FACILITY POST-EXAMINATION COMMENTS

FOR THE PRAIRIE ISLAND INITIAL EXAMINATION - AUGUST 2005

Prairie Island Nuclear Generating Plant Units 1 and 2
Dockets 50-282 and 50-306
License Nos. DPR-42 and DPR-60

Facility Recommendations for Prairie Island Nuclear Generating Plant (PINGP) Reactor Operator (RO) and Senior Reactor Operator (SRO) License Examination Changes

FIGURE B20.6-7b - GROUP B PRESSURIZER HEATER DIAGRAM

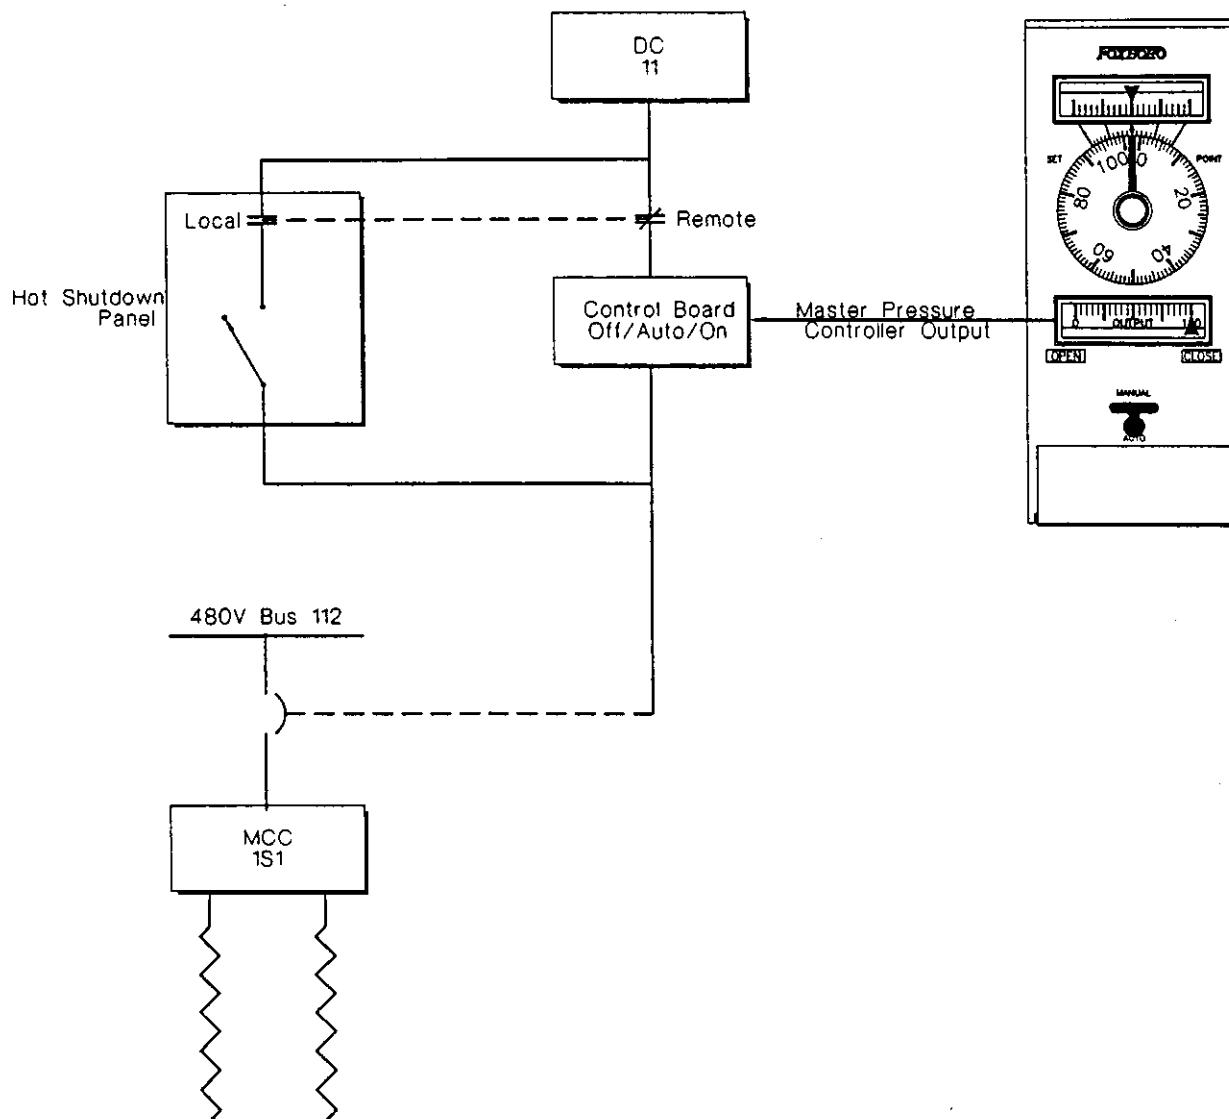
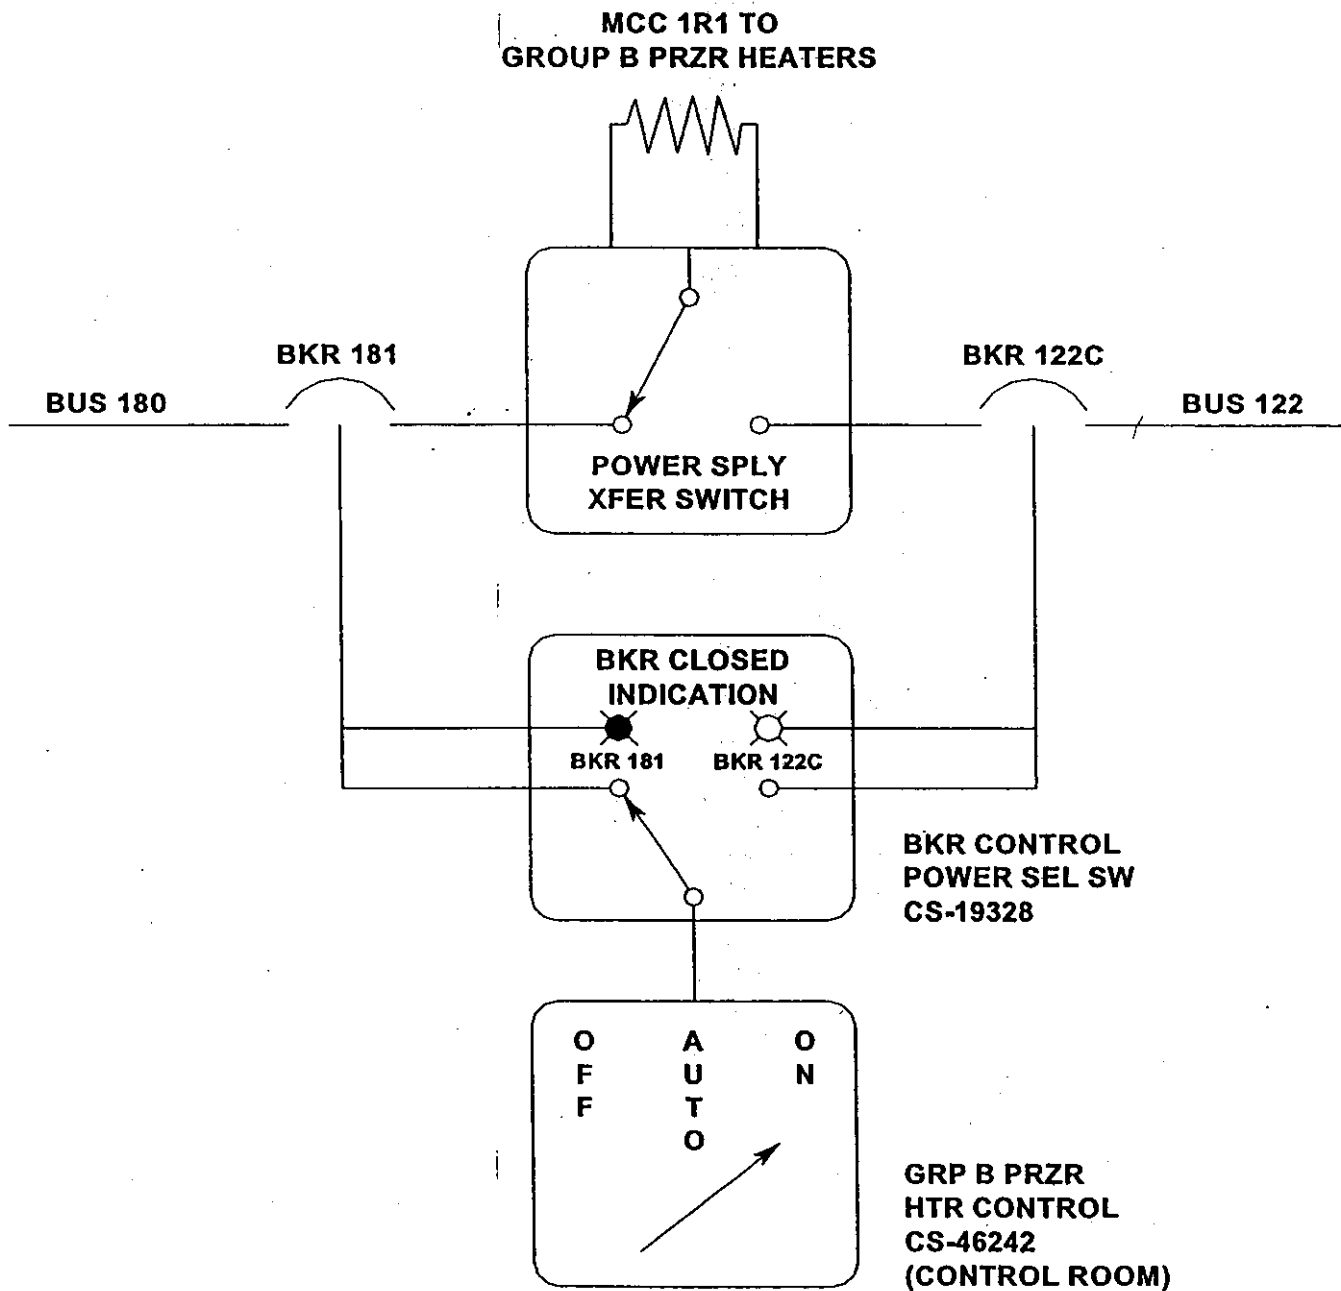
Reference NUREG 1021, Appendix E Part B.7 states not to assume conditions that are not specified in the stem of the question. Due to the fact we are trained to assume a normal lineup makes "C" and "D" correct.

A normal Pressurizer Heater Lineup would have Bank A powered from a safety-related source and banks B, D and E from a non-safeguard source that would be deenergized based on stem conditions.

ERCS display "M1.97" displays the power (KW) supplied to A and B heater banks. If a normal lineup is assumed, the operator could verify power to Bank A while knowing power is lost to banks B, D and E. This would make answer "C" correct.

Since the ERCS display will show the status of banks A and B regardless of electrical lineup, and states correctly that D and E Banks are deenergized regardless of breaker indication in the second part, "D" is also correct.

Recommend accepting both answers "C" and "D".
